# TECHNICAL SERVICE BULLETIN

# TECHNICAL SERVICE BULLETIN

# TECHNICAL SERVICE BULLETIN

# TECHNICAL SERVICE BULLETIN

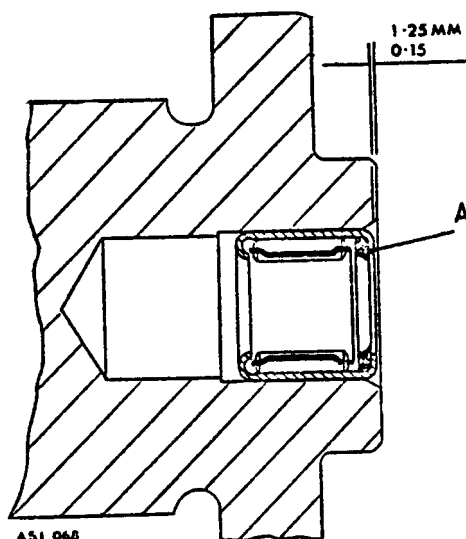
In the event that a TR7 owner should complain of a squealing noise emanating from the spigot bush in the rear of the crankshaft on 1975 and 1976 TR7s, this can be overcome by the installation of a needle roller bearing, part #UKC 8154 in place of the bronze spigot bush. (Refer to diagram).

6. Insert needle roller bearing, part #UKC-8154, with the integral seal A (refer to illustration) facing the gearbox side. The needle roller bearing is to be pressed into the crankshaft to the dimension shown in diagram.

ILL. B - OLD SWITCH

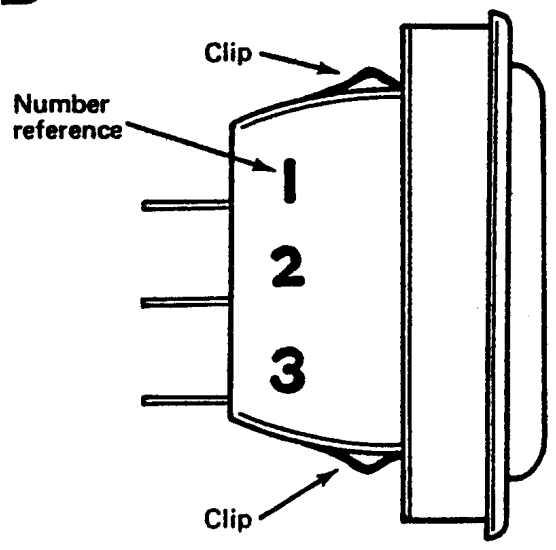
3. Mark position (or make a note) of the three wires using reference on switch (1, 2 & 3) before removing each of them from the switch terminals (see illustration B).	3. Mark position (or make a note) of the three wires using reference on switch (1, 2 & 3) before removing each of them from the switch terminals (see illustration B).

ILL. E - LUCAS SWITCH

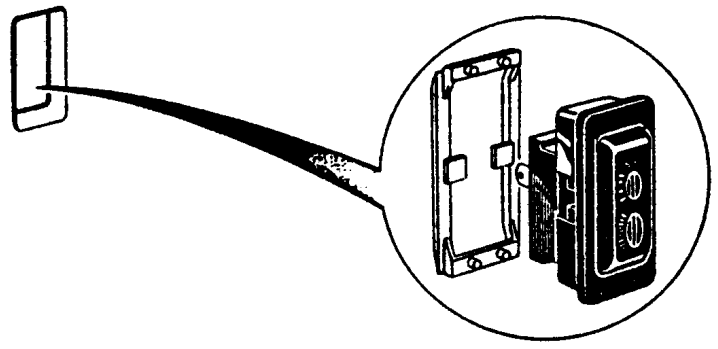
6. Break away flange with pliers and trim opening of panel with a file, if necessary.	6. Note terminal numbers on Lucas switch. Connect wire 1 thru 3 to the corresponding terminals as in illustration E).

ILL. C - FIGURE 1

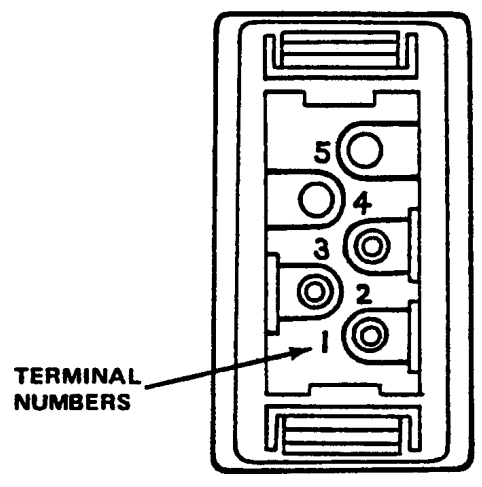
5. Lay dash panel face down on a clean flat surface. Using switch flange as a guide, score downwards with a sharp utility knife (see illustration C - figure 1).	5. Insert switch into dash, hold switch in position and secure retainer clip to switch as illustrated in figure D below.

ILL. C - FIGURE 2

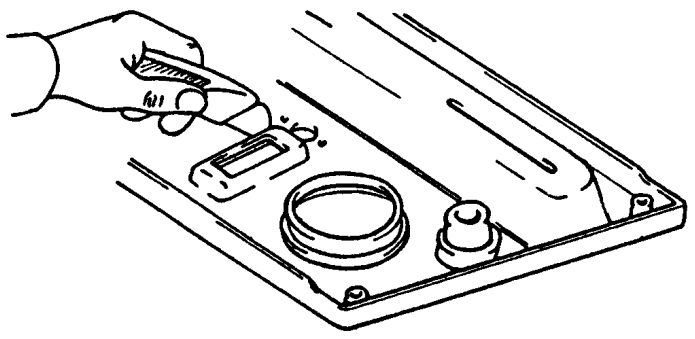
7. Install switch in face of dash panel and secure with Tinnerman "S" clips (see illustration C - figure 2).	7. Install wood dash center panel.
8. Note terminal numbers on Lucas switch and connect wire 1 thru 3 to the corresponding terminals (see illustration E).	8. Connect battery ground terminal and test lights. Position 1 (first click), parking lights - position 2 (second click), headlights.
